BOARD OF ZONING APPEALS STAFF REPORT

Agenda Item: BZA 24-011

Application Type: Developmental Standards Variances

Property Address: 7949 Calumet Ave

Monument Sign:

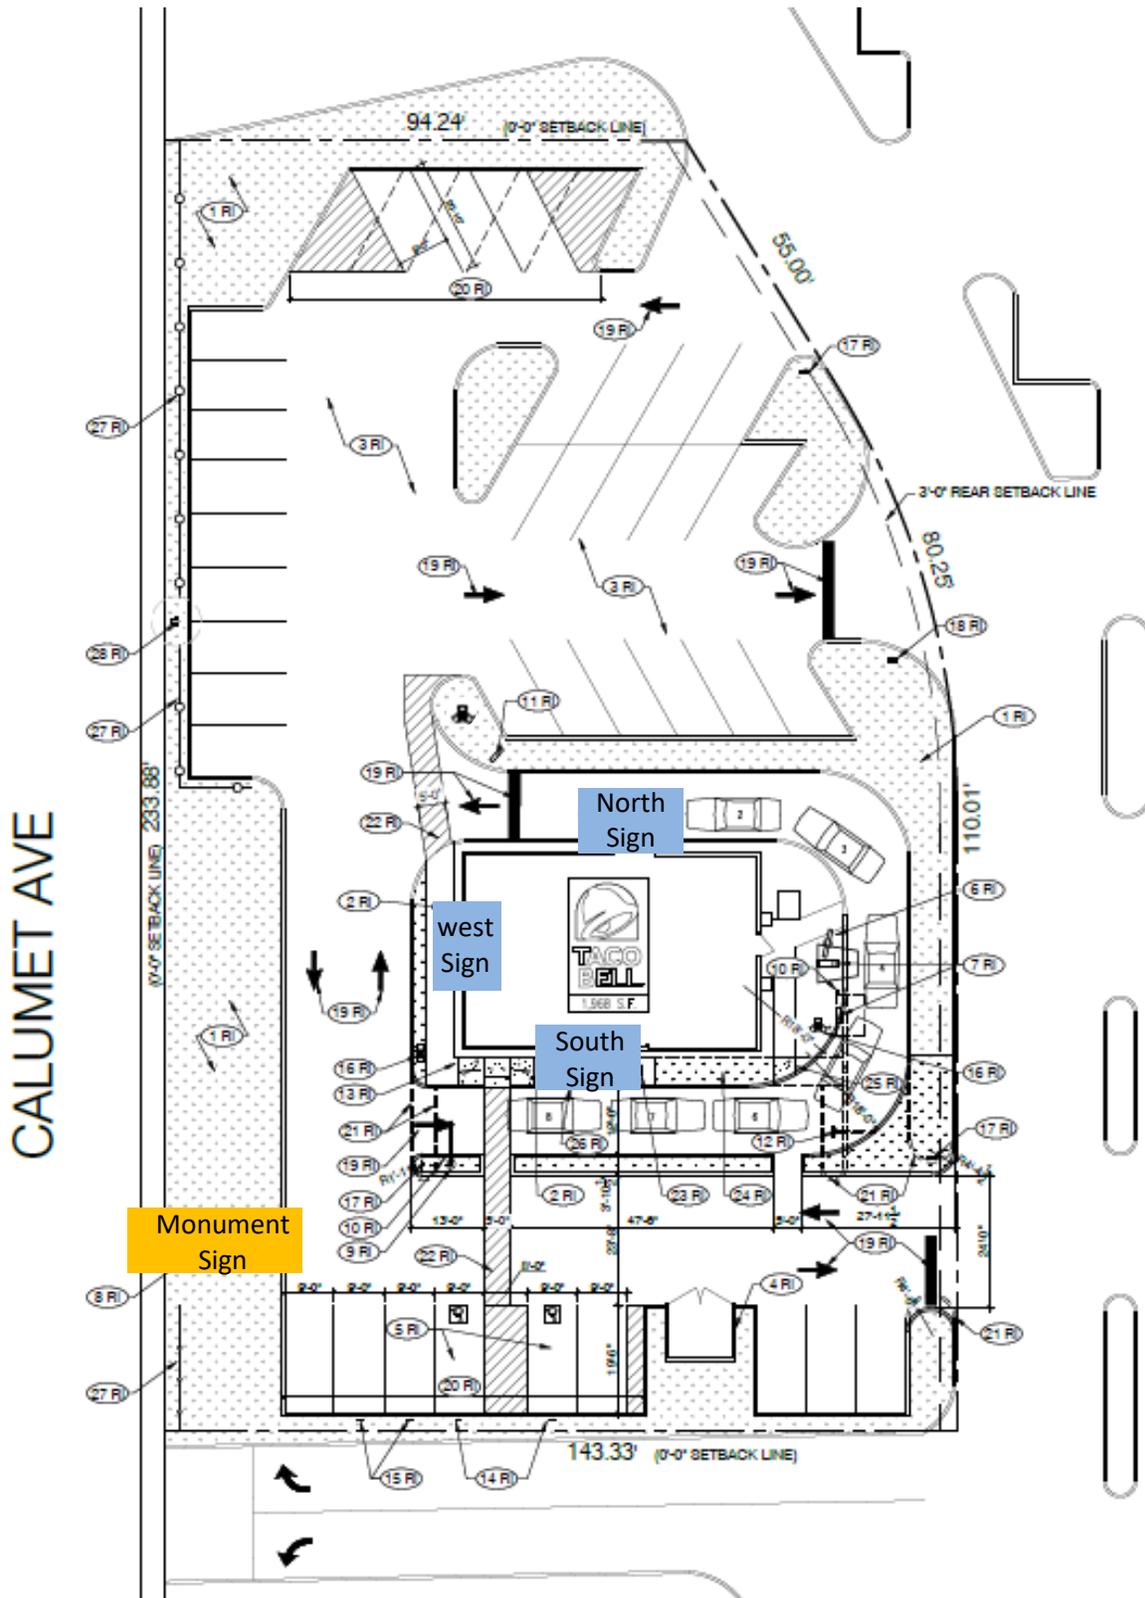
The applicant is requesting to utilize an existing cabinet sign that is legal non-conforming. Since the proposed changes do not bring the sign into compliance with standards a variance must be received to bring the sign fully into compliance.

1. Area (Max): 18-sf | *Proposed 32.76-sf*
2. Height (Max): 6-ft including base | *Proposed in excess of 6-ft*
3. Letter height (Max): 12-inches | *Proposed unknown*

4. (d.) Materials: shall have a Sign face made of authentic brick, stone, or solid metal or wood, with lettering, logo or branding made of solid metal or channel lettering | *Proposed Sign face is polycarbonate with vinyl digital print.*

Motion to APPROVE the light pole height and head type; motion to Approve the monument sign with the condition that changeable copy complies with the sign material outlined in the character based zoning code; motion to Approve the north and south wall sign with the condition that they comply with the character based zoning code; motion to deny the west wall sign for BZA 24-011, including all discussion and findings.

Wall Signs:

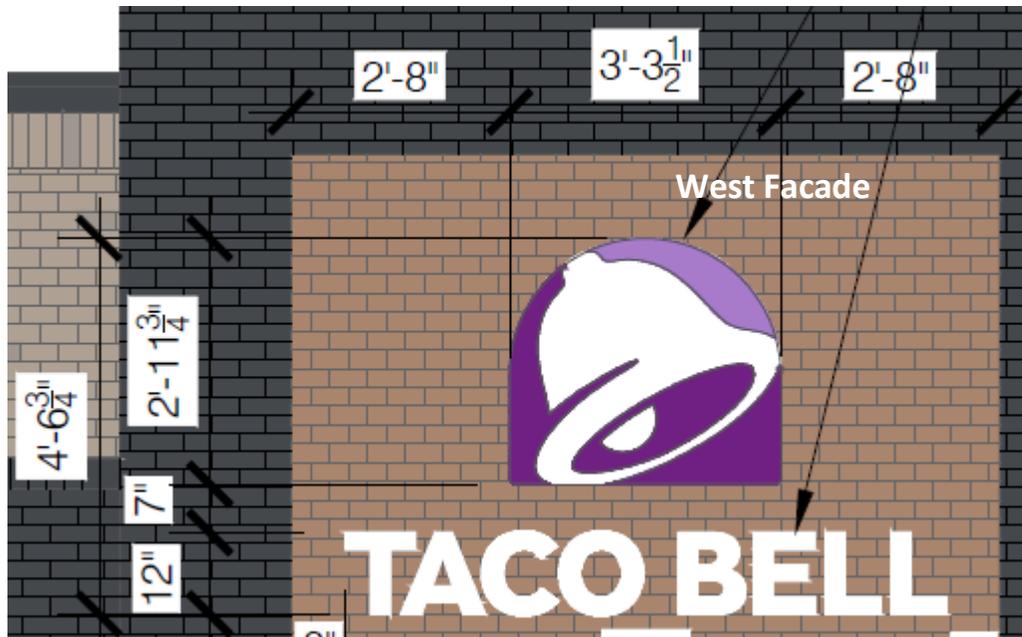
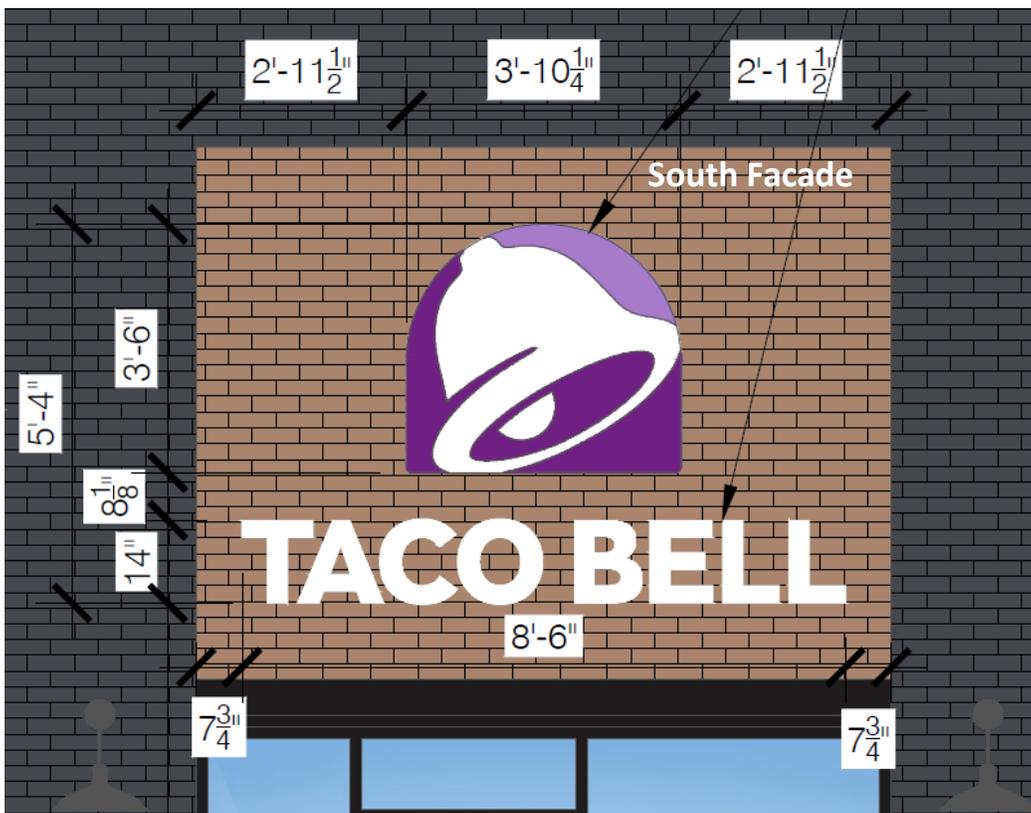
The applicant is requesting new wall signs on 3: one on the north façade (drive aisle), one on the south façade (drive aisle), and one on the west façade facing Calumet Avenue. Only the west façade sign is permitted per code along the primary façade of the building.

1. Quantity (Max): 1 per Façade – the building has 1 Façade (west) | *Proposed two (2) additional signs (north & south sides of the building*
2. Area: 1.5-sf per linear ft of Façade or business Frontage (53-ft x 1.5) = 79.5-sf allowance for west wall sign | *Proposed north and west sign area: 33.5-sf; Proposed south sign area: 45.3-sf; Total sign area proposed: 112.3- sf*
3. Additional Standards, Sign Size, Overall Height (Max): 36-inches | *Proposed north and west wall sign height: 54.75-inches; Proposed south wall sign height: 64-inches*

4. (d.) vinyl may not be used to create any design | *Proposed swinging bell, both 36-inches and 42-inches, purple logo signs – materials unknown*

- Material of the face/design on the 36-inches and 42-inches swinging bell, purple logo wall signs.

Staff's review finds that the additional lighting to match existing head light type and height will be consistent with the overall development of the site. In addition, staff finds that the north and south wall signage may prove to be necessary to maintain consistency with historic wall sign location along the drive aisle. Staff finds the same sign of the north wall is not necessary to maintain consistency with historic wall sign locations. Finally, staff supports the monument sign maintain its legal non-conformity so long the non-conformity is not further brought out of compliance and recommends all signs comply with the wall and monument sign standards material and bulk regulations.

Lighting plan:

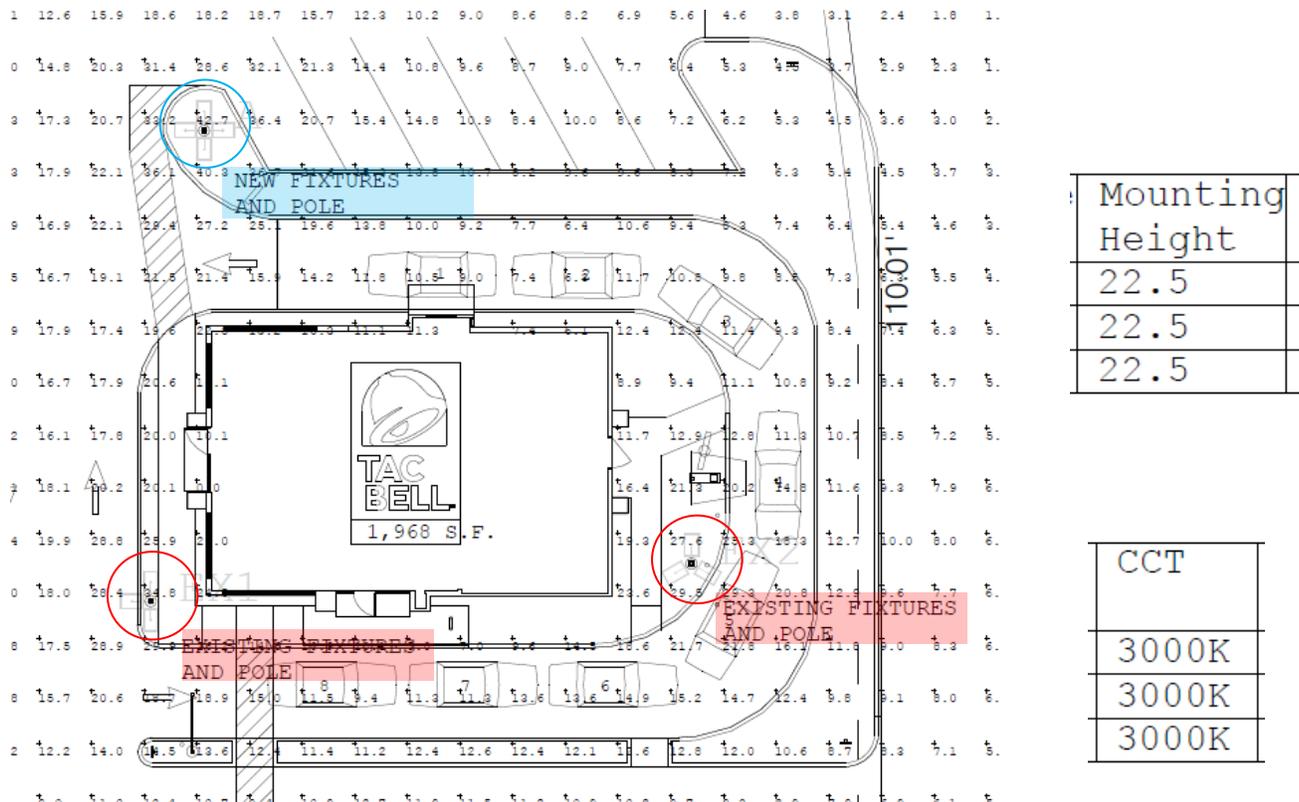
The applicant is requesting one lighting pole that exceeds the maximum height and that does not comply with the light head type. The maximum height is 20’ and the applicant is proposing 22.5’ and the proposed head type is Cobra which does not conform to the town Colonial, Coach, or Acorn, to match two pre-existing pole lights heights and head type.
